SUBJECT: DEMONSTRATION / DELIVERY HOLD - Safety Recall 12S33
Certain 2012 Model Year F-650 and F-750 Vehicles
Windshield Urethane Seal Inspection and Repair

DEMONSTRATION / DELIVERY HOLD – Safety Recall 12S33

CERTAIN 2012 MODEL YEAR F-650 AND F-750 VEHICLES — WINDSHIELD URETHANE SEAL INSPECTION AND REPAIR

FIGURE 1

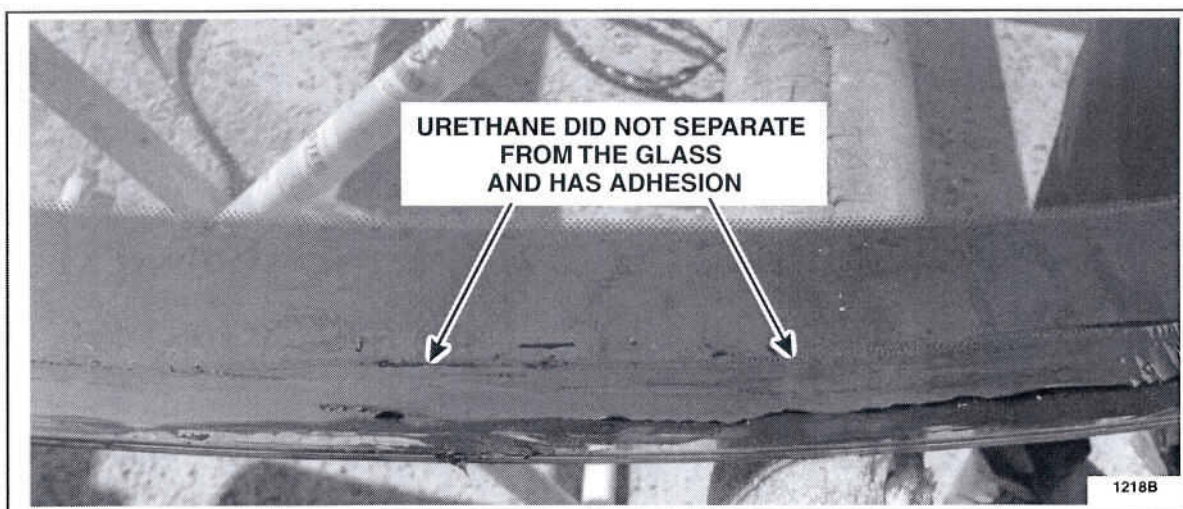
- a. If the urethane separates from the glass cleanly and easily (see Figure 1), the primers were not applied to the glass. If the windshield is not damaged, the windshield is to be cleaned and re-used. Proceed to Cleaning Procedure on Page 3.
- b. If it is difficult to slide a razor blade or sharp putty knife under the urethane and/or the urethane has adhesion at any portion around the glass (see Figure 2), install a new windshield. Proceed directly to Installation Procedure on Page 3.
